# 2020 Corvette: Service Bulletin: #N202302840: Service Update - Door Paint Chipping

**Subject:** N202302840 — Door  
Paint Chipping  
**Models:** 2020 Chevrolet Corvette

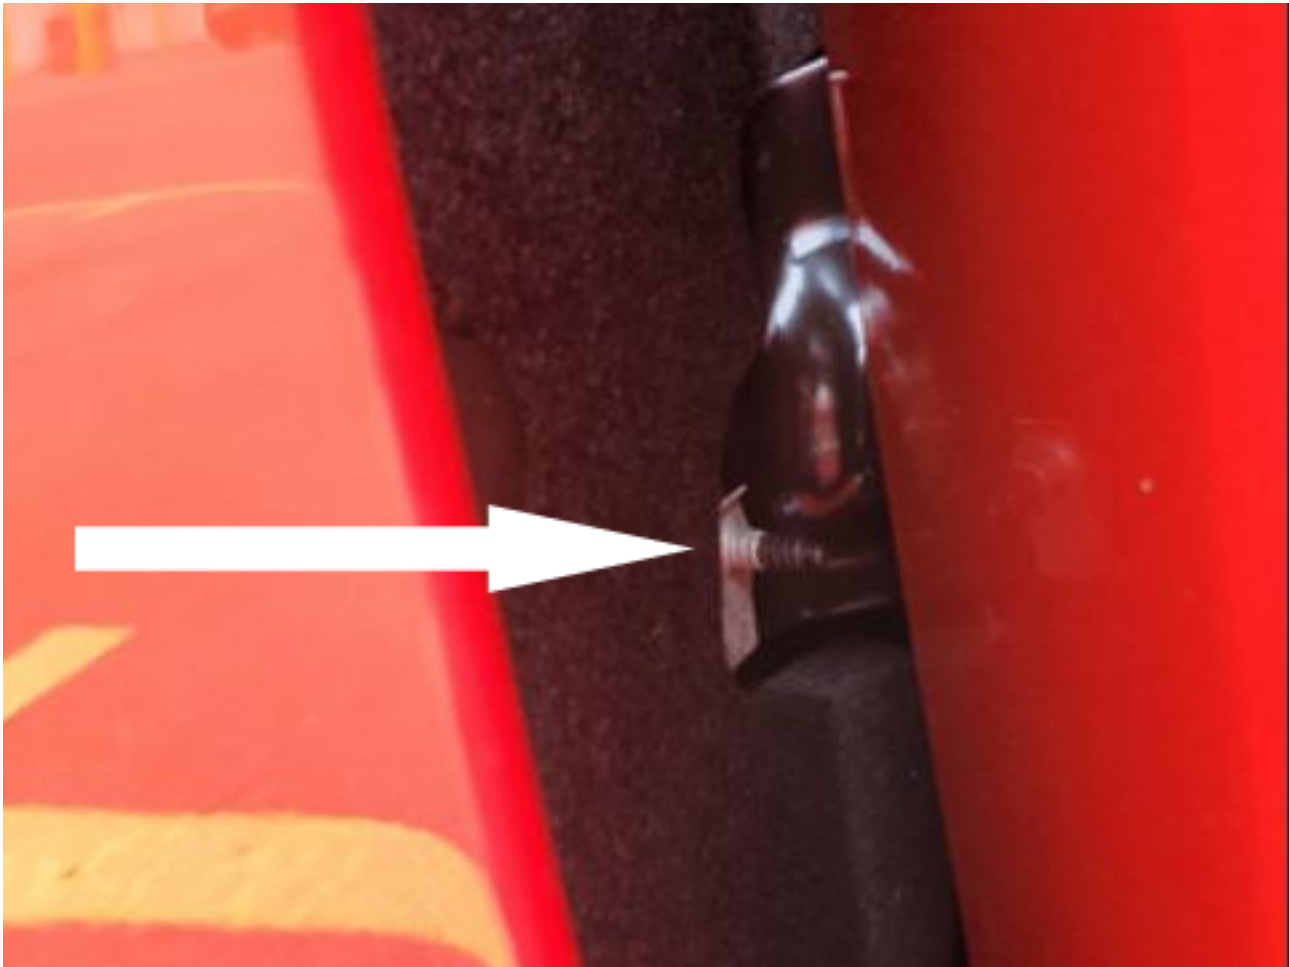
1. Carefully open the left front door inspecting for any contact with the fender fastener. This fastener is located just below the door check strap area.
2. Locate the threaded portion of the fender mounting bolt where

it exits the nut.

3. Count the number of threads showing.

- If less than 1 full thread is showing, no further action is required.

- If more than 2 threads are showing, proceed to step # 4.
- Partially remove the wheelhouse liner to access the rear fender mounting fasteners. Refer to *Front Wheelhouse Liner Replacement* in SI.
  1. Locate and remove the center fender to body fastener as shown.
  2. Install the shorter service fastener. Tighten  $9\text{ Nm}$  ( $80\text{ lb in}$ ).
  3. Reinstall the wheelhouse liner. Refer to *Front Wheelhouse Liner Replacement* in SI.
  4. Repeat steps 1-7 on the right side of the vehicle.

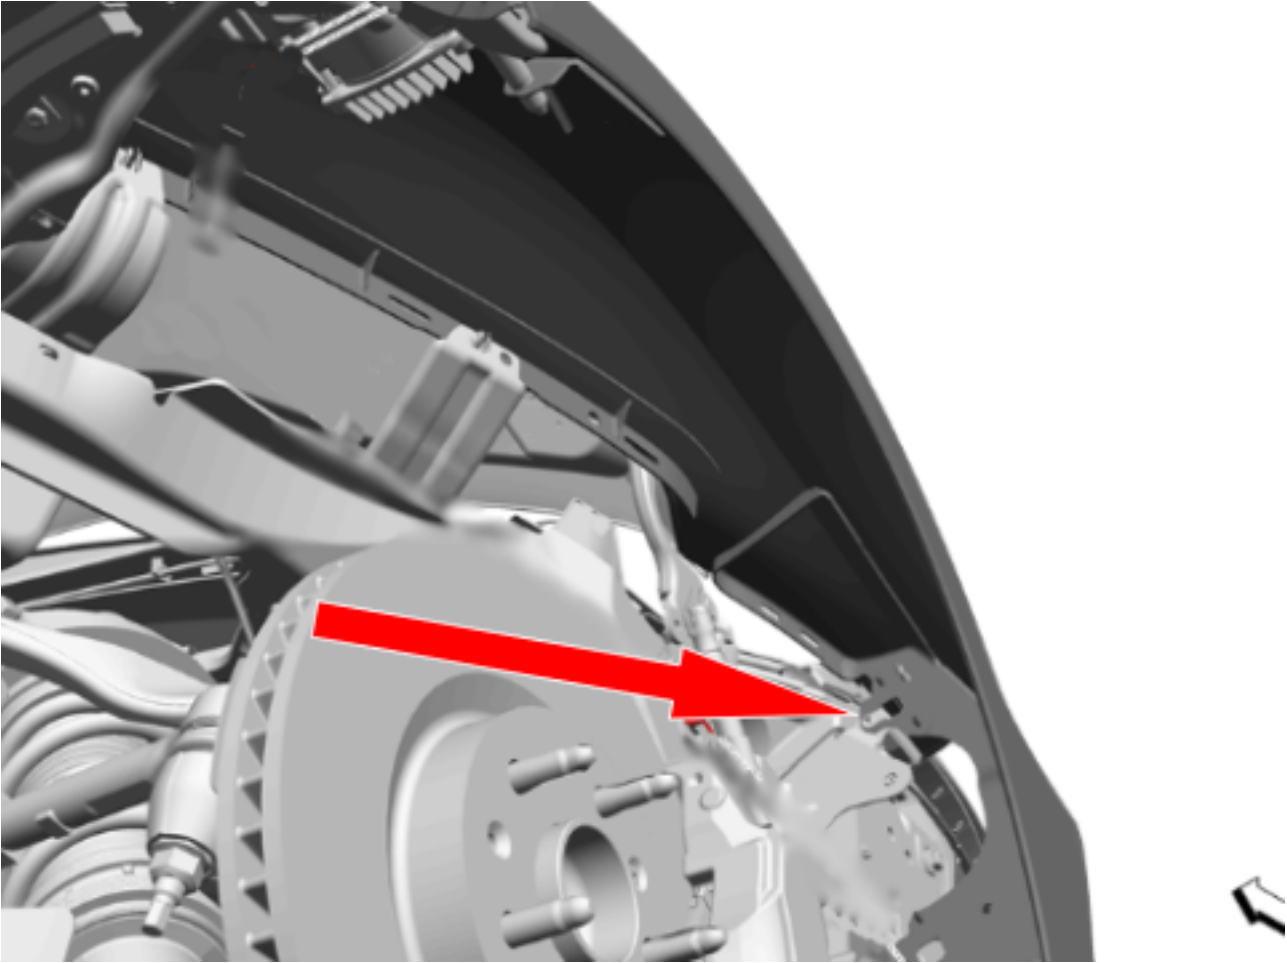
*Condition* Certain 2020 model year Chevrolet Corvette vehicles may have a fender

mounting bolt that is too long, and could come in contact with the door. Dealers will inspect and replace the fender mounting bolt if necessary.
